Final Report - Corrections Required **Application No. LUPL-25-0008**

Document Filename : 241010_BLR Village C Land Use Plan.pdf

BANNING LEWIS RANCH - VILLAGE C
LAND USE PLAN
COLORADO SPRINGS, CO
LAND USE PLAN

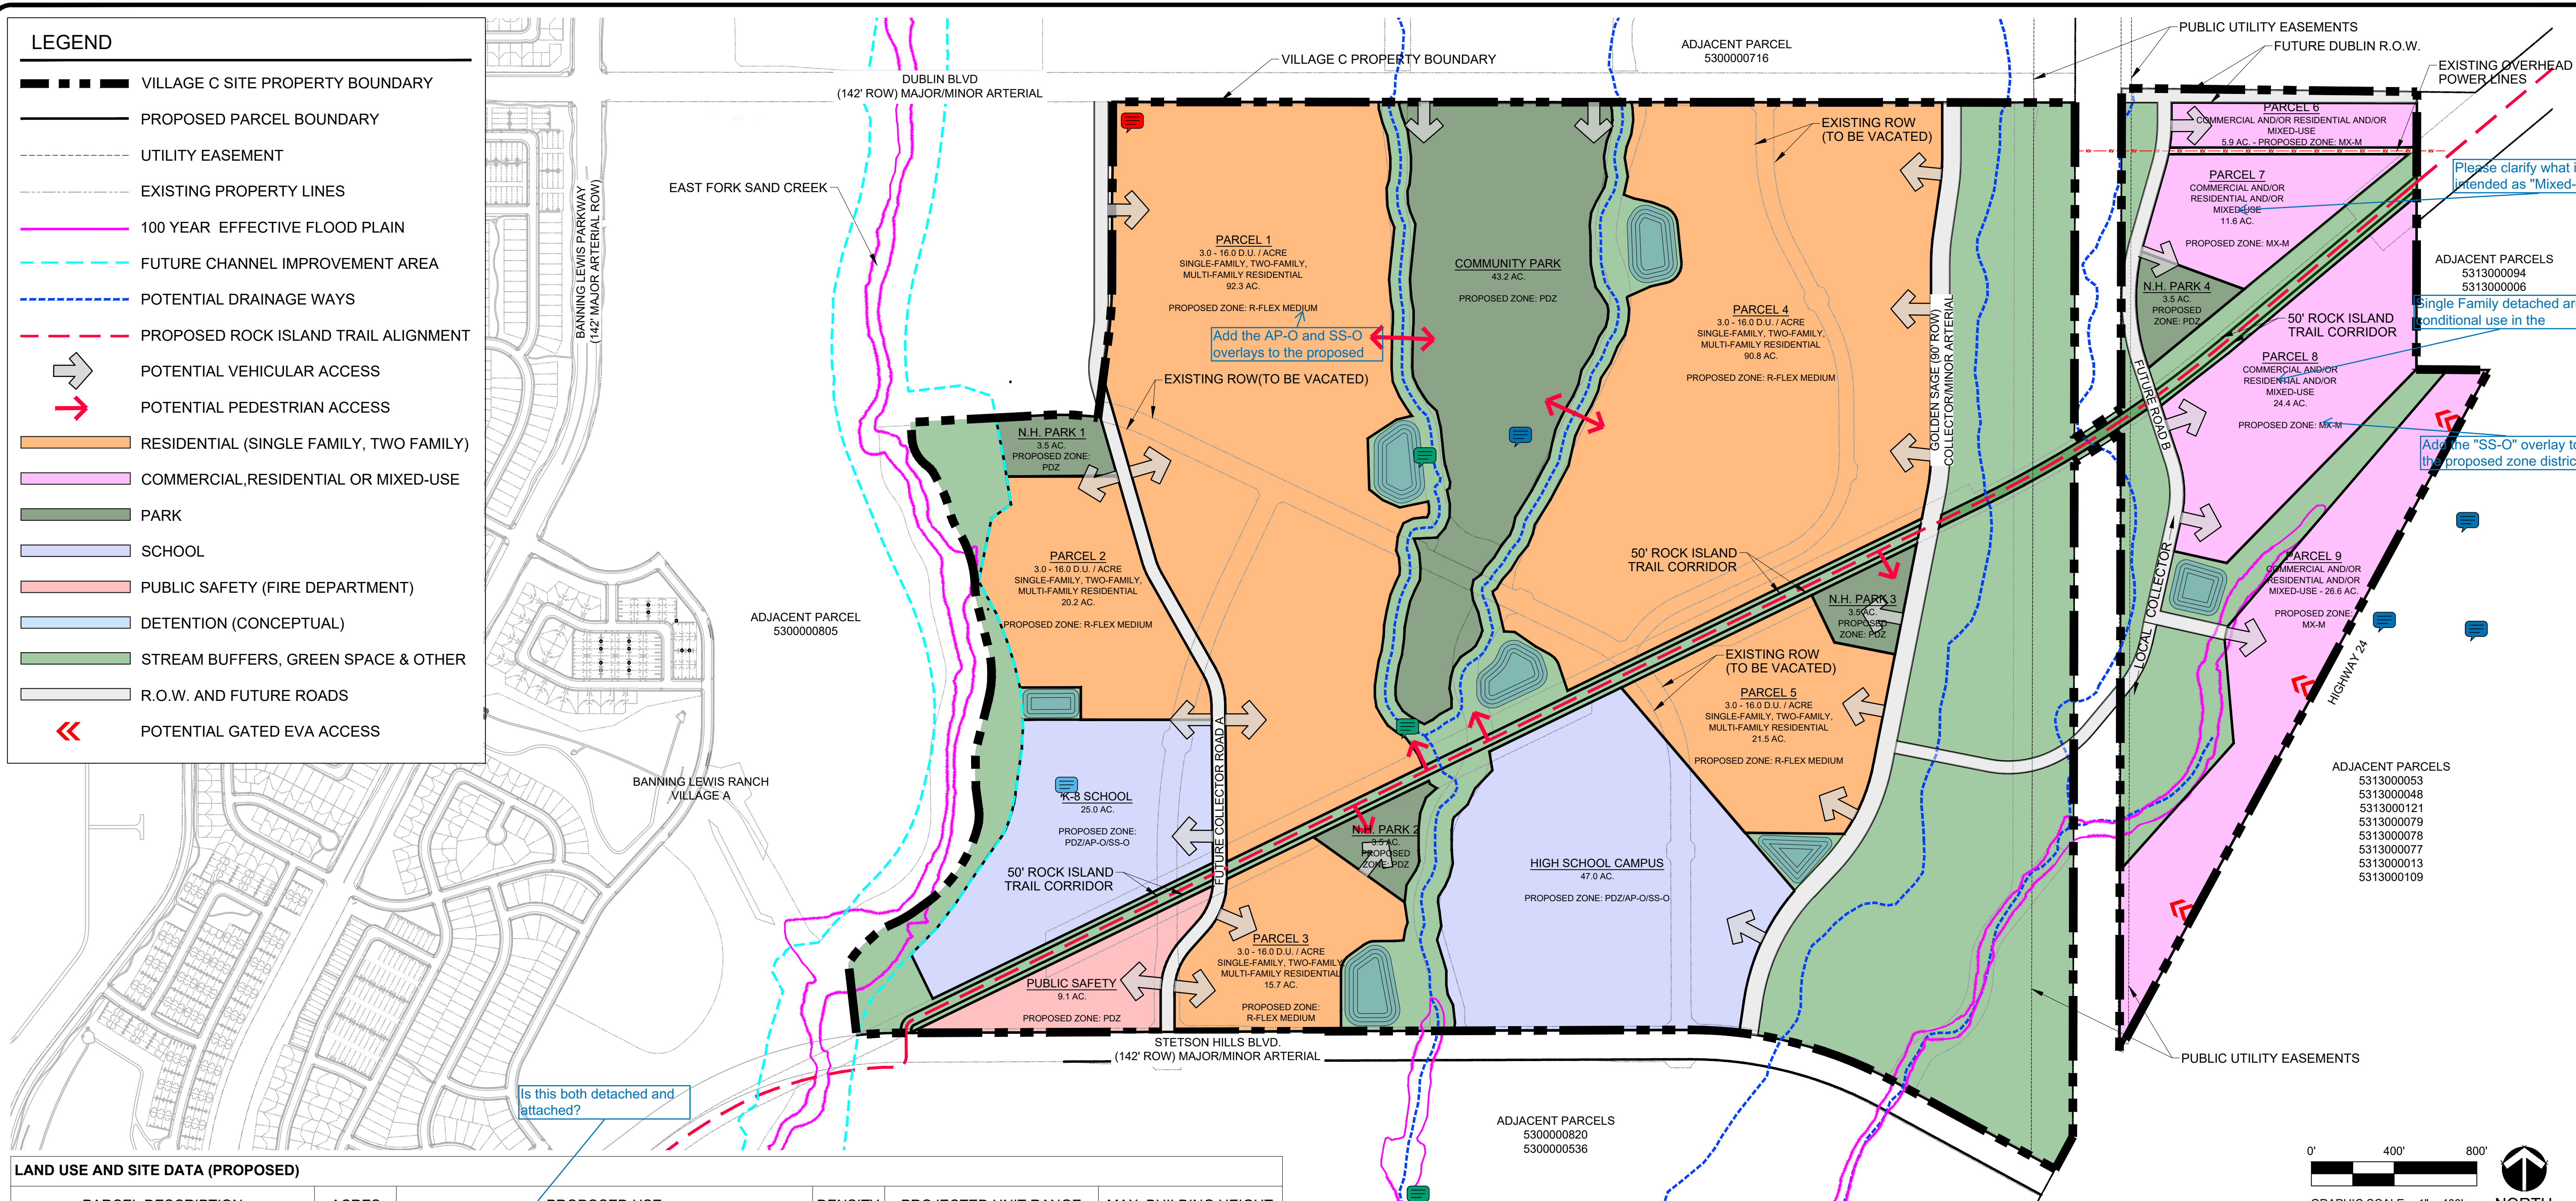
Comment ID	Page Reference	Reviewer : Department	Review Comments
9	1	Erica Schmitz : City Engineering - SWENT	The existing channel must be shown and labeled and if the existing channel is not stabilized, it may be required to be stabilized. Please reach out to the Lead Reviewer to set-up a meeting to discuss the channel improvements and to schedule a site visit.
10	1	Erica Schmitz : City Engineering - SWENT	Add a note calling out channel improvement requirements associated with the Site, including responsible party, long-term maintenance responsibility, and timing requirements. If not applicable, provide a note stating channel improvements are not required.
11	1	Erica Schmitz : City Engineering - SWENT	Info Only: Please contact the Lead Reviewer, Erica Schmitz (erica.schmitz@coloradosprings.gov) with any questions related to SWENT comments. Please reference the Planning review number in all communications.

Comment ID	Page Reference	Reviewer : Department	Review Comments
6	1	Joel Dagnillo : City Engineering Dev Review	Please add the following note to Cover Sheet: "This property is subject to the findings, summary and conclusions of a geologic hazard report prepared by Entech Engineering, Inc. dated May 1, 2020 (revised June 17, 2020), which identified the following specific geologic hazards on the property: areas of hydrocompaction, loose soils, potentially expansive soils, erosion, seasonal and potentially seasonal shallow groundwater areas, ponded water, floodplains and artificial fill. A copy of said report has been placed withing the subdivision file of the City of Colorado Springs Planning and Development Team. Contact the Planning and Development Team, 30 South Nevada Ave, Suite 701, Colorado Springs, CO, if you would like to review said report."
7	1	Joel Dagnillo : City Engineering Dev Review	Add a note stating the timeline in which Dublin and Stetson Hills will be constructed and by whom.

13	1	Joel Dagnillo : City Engineering Dev Review	All public improvements to be built to City Standards, and specifically called out as so on forthcoming Development Plan(s). Construction plans and financial assurances will also be required as this project progresses.
8	2	Joel Dagnillo : City Engineering Dev Review	All accesses and required public improvements along Highway 24 will have to be coordinated with CDOT.
1	1	Matthew Alcuran : Col Springs Utilities	**Springs Utilities comment to applicant: Springs Utilities comments will be provided at the time of the required Preliminary Utility and Public Facilities Plan submittal associated with the development plan entitlement.
14	2	Steve Smith : Fire	For response purposes, the fire station/public facility location, is better suited in this corner.
3	1	Allison Stocker : Planning	Informational reminder to staff: Prior application is under PDZL-24-0005

15	1	Caroline Miller : Planning	PLDO Reviewer would like for Village B2 and C to go to Parks Advisory Board prior to City Planning Commission to highlight PLDO obligations through the Master Plan/Land Use Plan and how they are to be met through the spread of Neighborhood Parks and summed Village C Community Park site. This will take two months, the first month as a presentation item, the second month as an action item, once Parks comments are resolved on Village C. In addition, Parks is awaiting feedback regarding the developer building the Community Park, then dedicating it to the city. A Community Park amenity list was provided in April to help the conceptual feasibility discussions. Notes will likely be added to this LUP in the future, upon developer response.
31	1	Caroline Miller : Planning	Please add a note that Rock Island Trail easements will be provided at time of adjacent development.

37	1	Tamara Baxter : Planning	I would reference the Development Standards Adjustments as well, as this will be applicable for future DPs.
39	1	Tamara Baxter : Planning	Change to "SS-O" per UDC. Correct through out plan set.
40	1	Tamara Baxter : Planning	Please look at the definition of dwelling specific to two family attached and two-family (duplex) attached. Please clarify if one or the other or both are intended.
48	1	Tamara Baxter : Planning	What is intended as 'mixed-use'?
51	1	Tamara Baxter : Planning	This comment is also applicable to the Development Standards Adjustment application(s). Please refer to UDC Section 7.4.201.C [Table 7.4.2-C] Notes 1 and 3.
56	1	Tamara Baxter : Planning	Identify which version. Thank you for including.
57	1	Tamara Baxter : Planning	Plannign staff reverses the right to provide additional comments with a resubmittal.

BANNING LEWIS RANCH - VILLAGE C
LAND USE PLAN
COLORADO SPRINGS, CO
PARK ANALYSIS

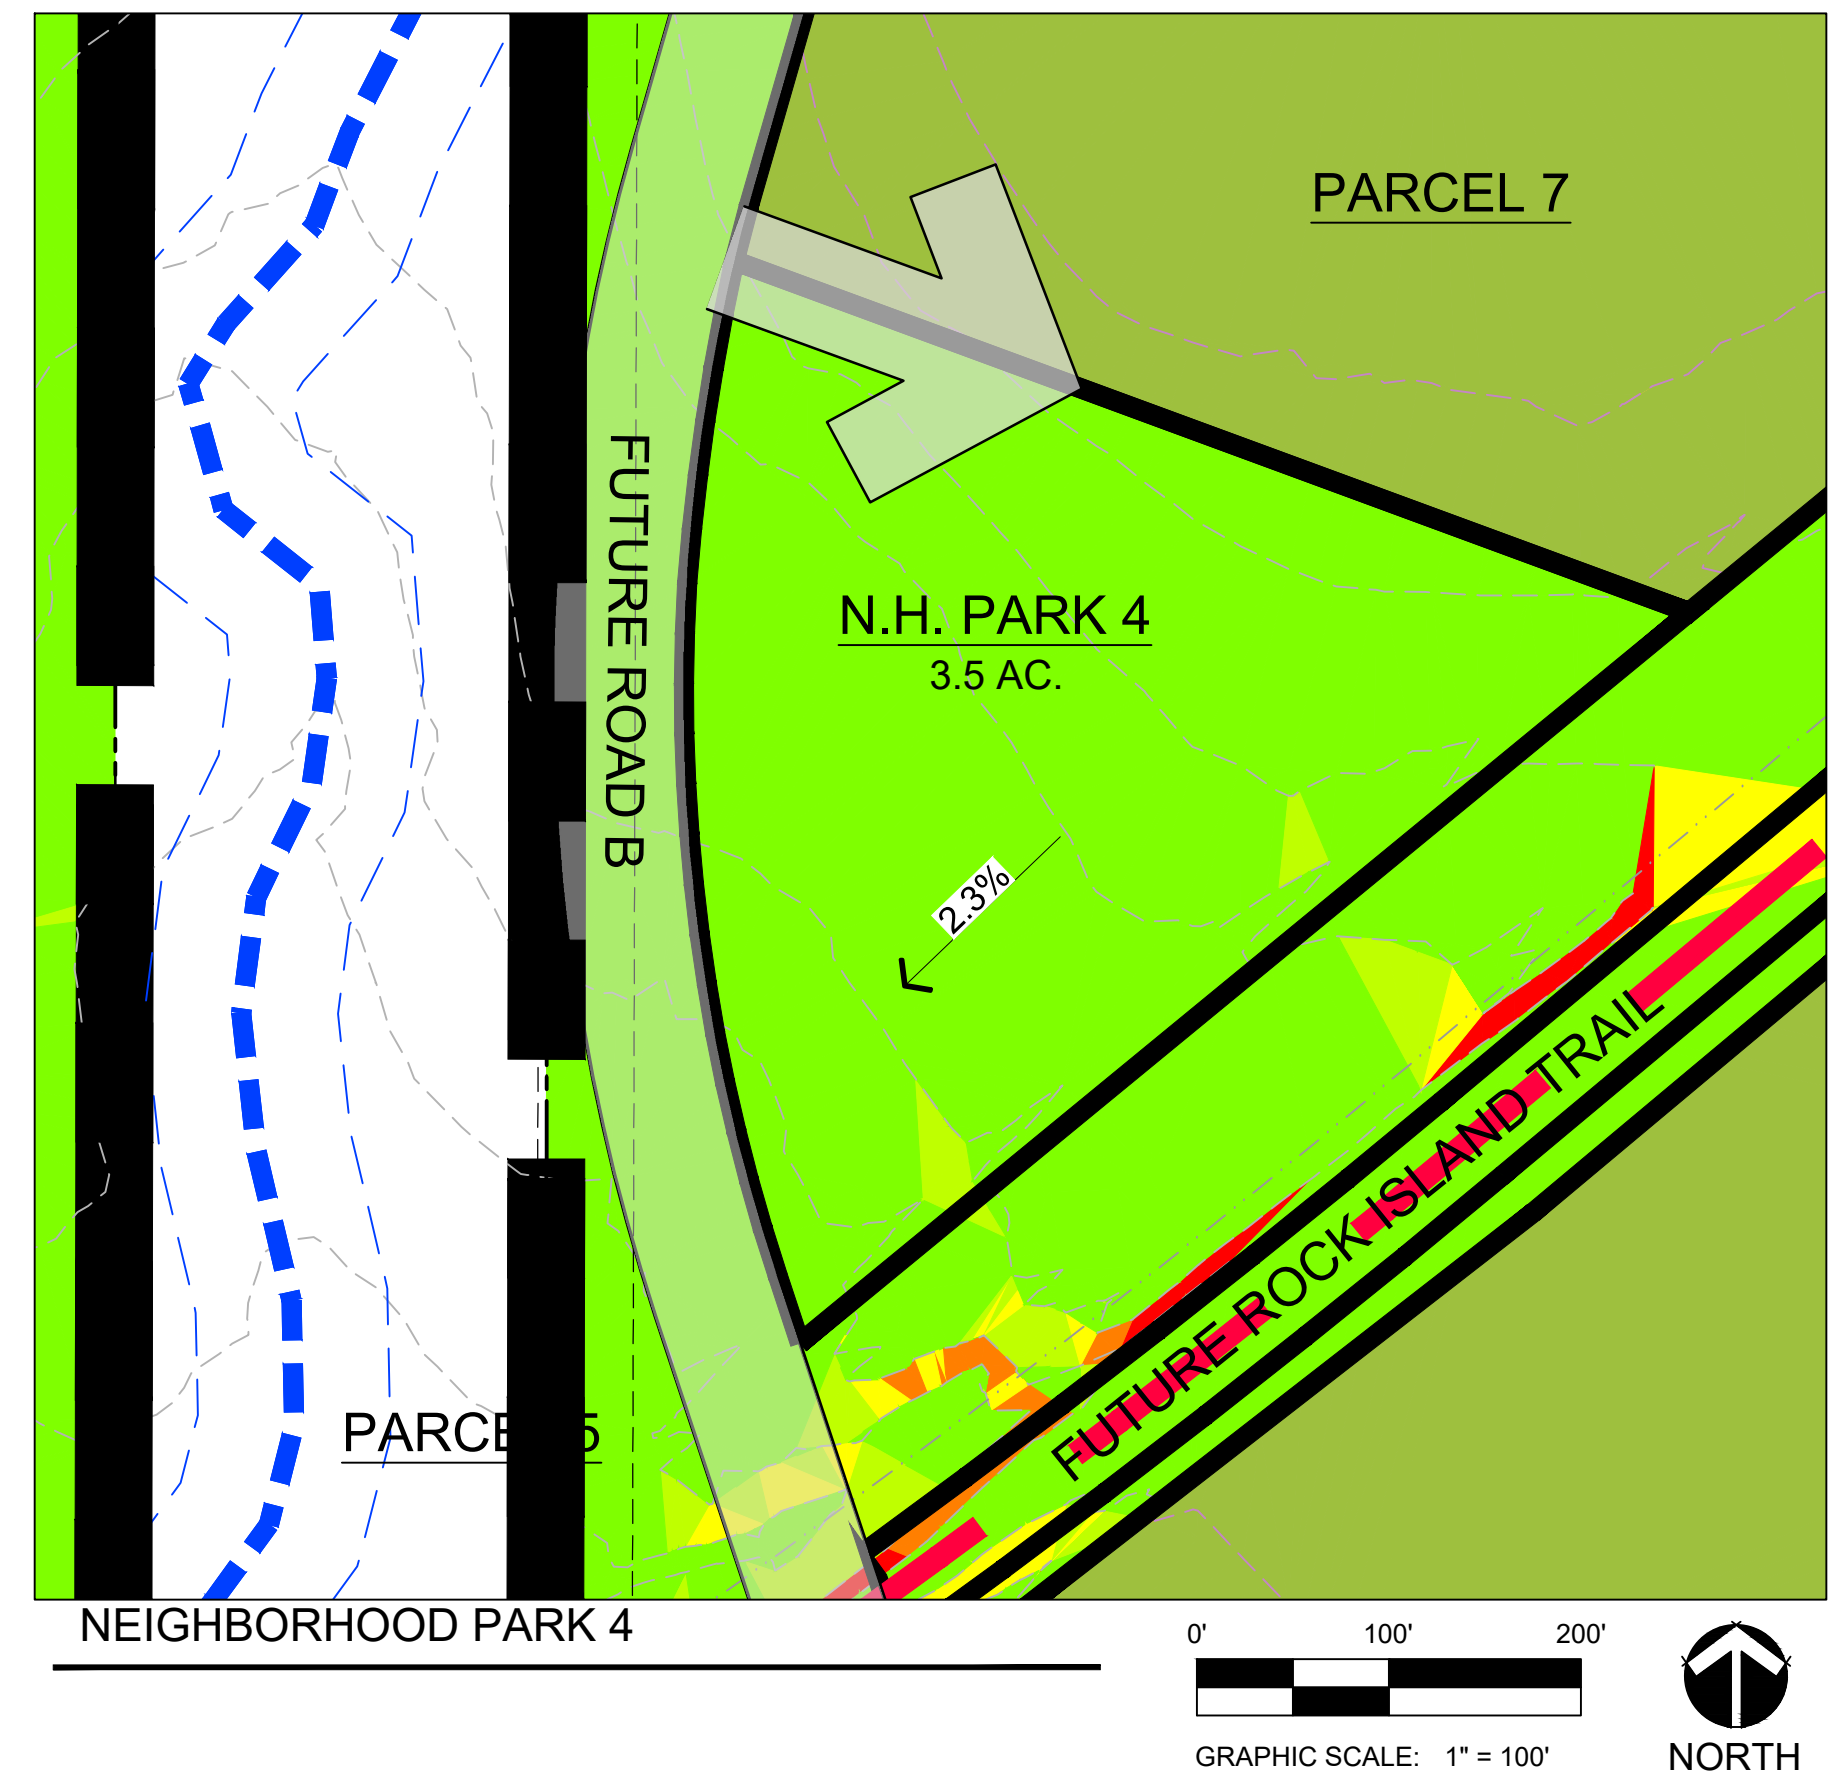
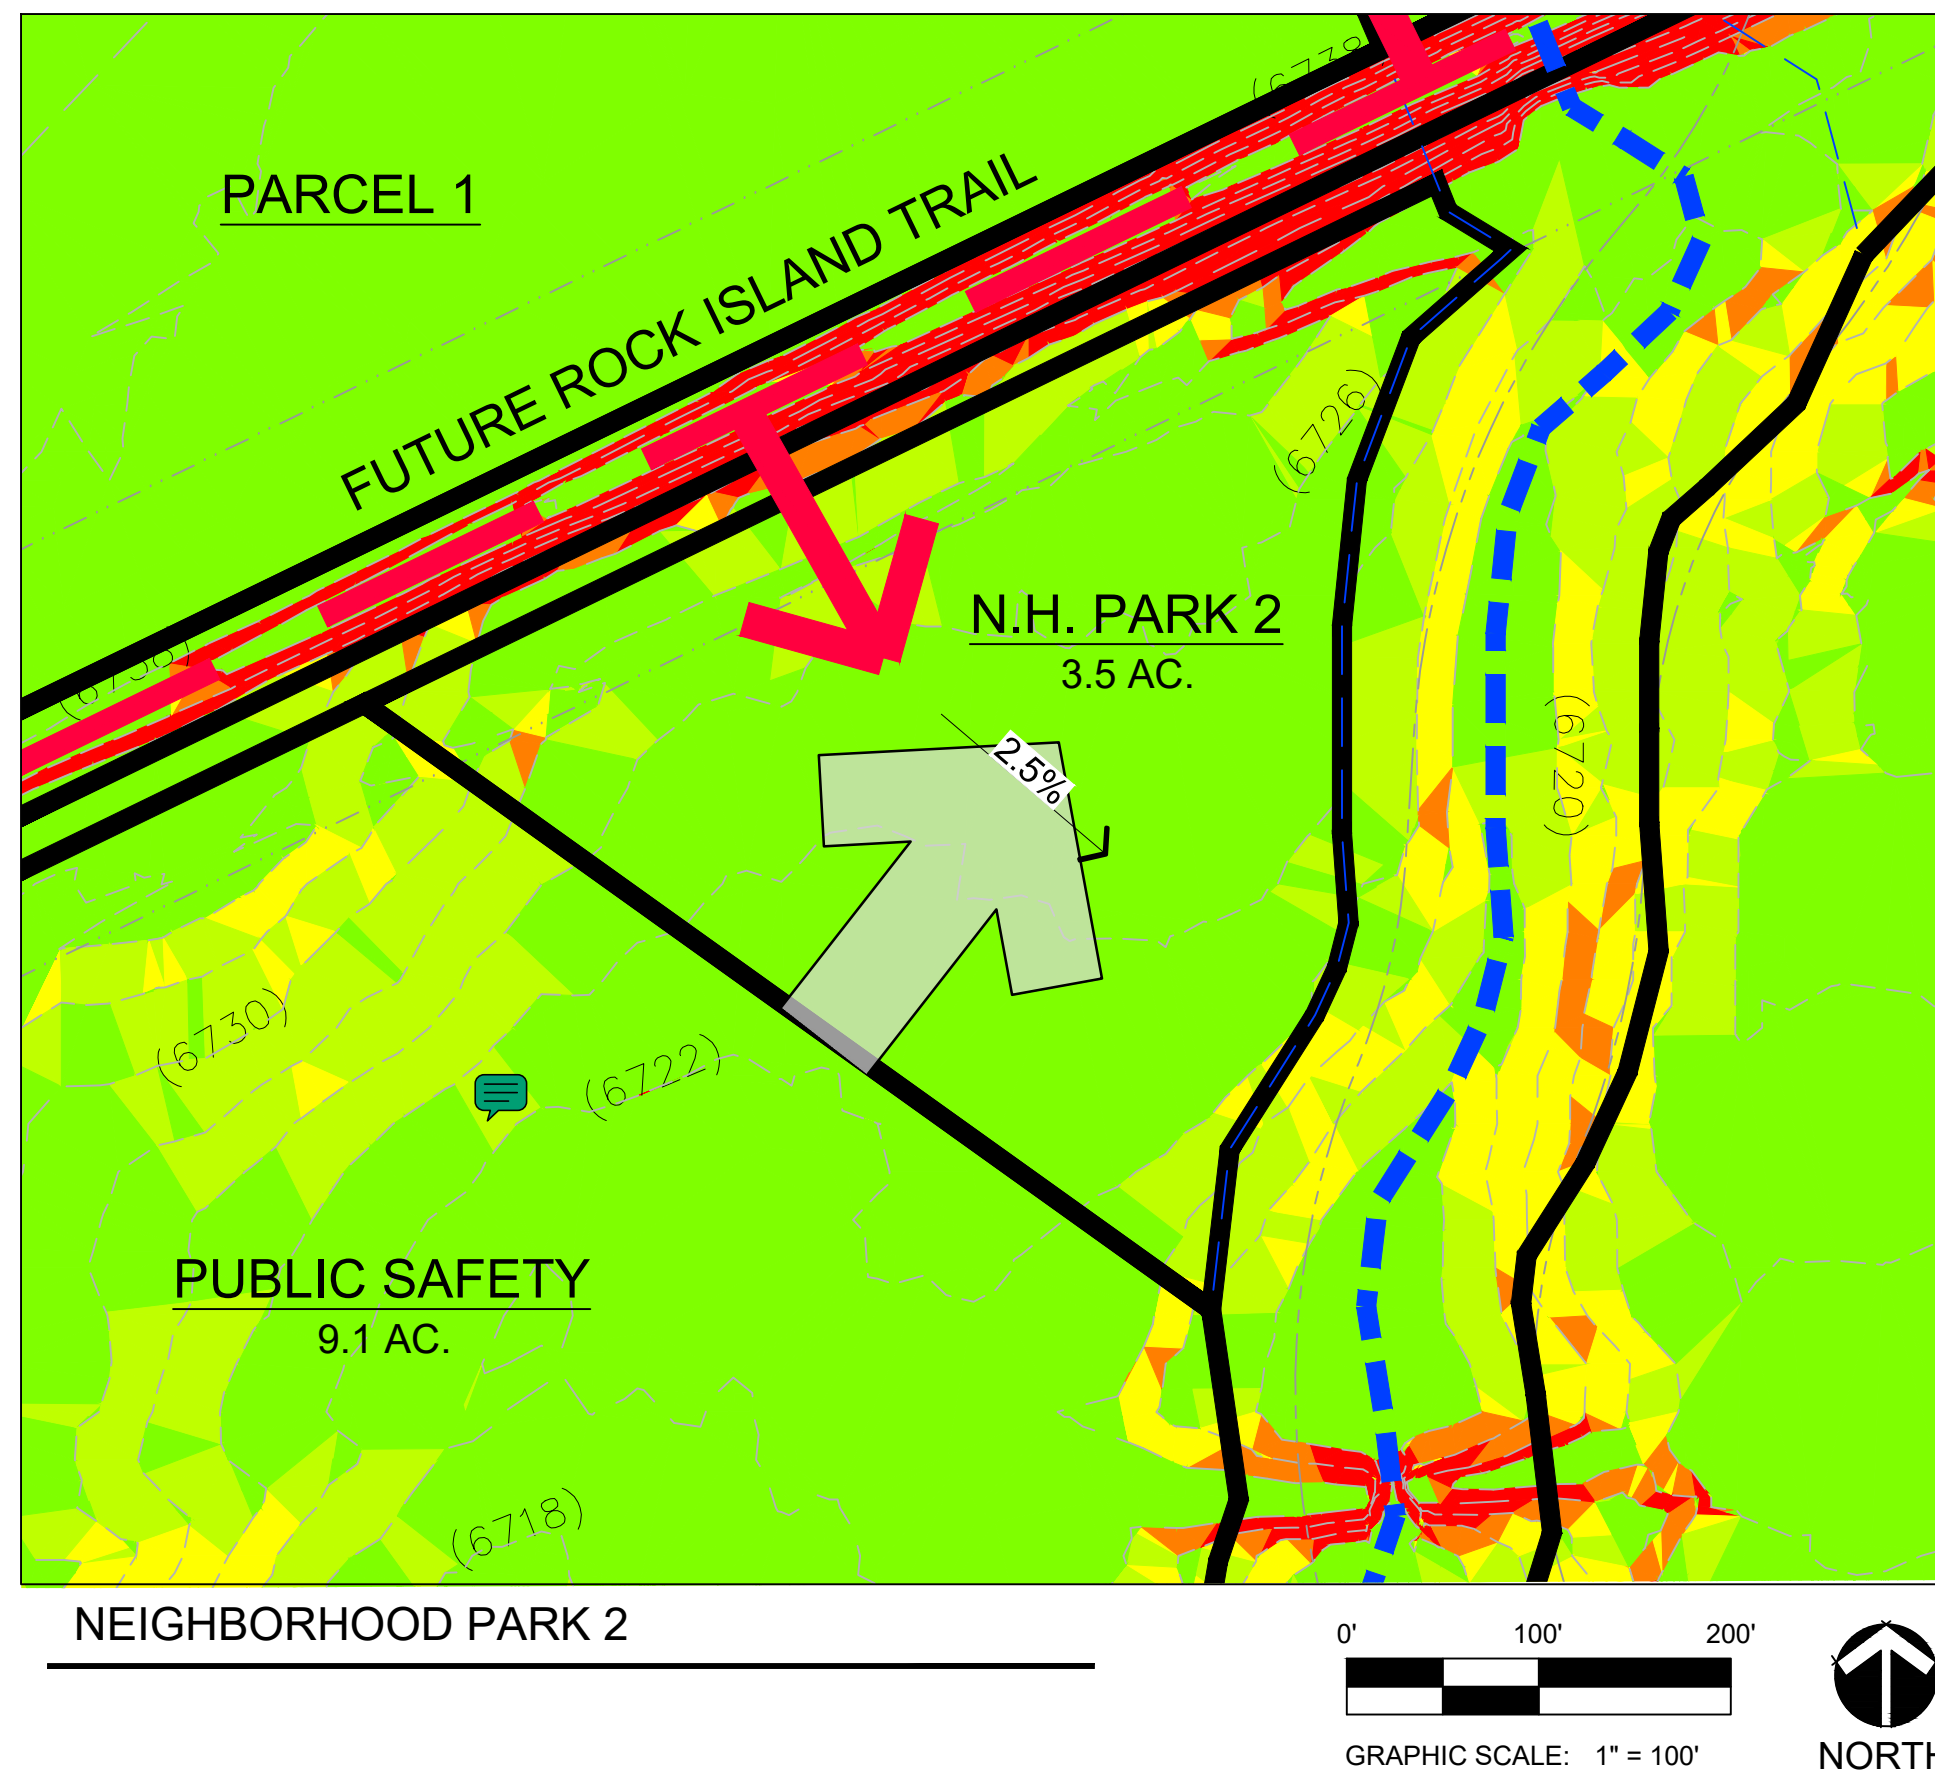
53	2	Tamara Baxter : Planning	Please use this on the coversheet as well.
54	2	Tamara Baxter : Planning	What does this residential encompass?
30	3	Caroline Miller : Planning	This graphic doesn't match the LUP Bubbles shown on page 2, park is not next to Public Safety.

Please use this on the coversheet as well.
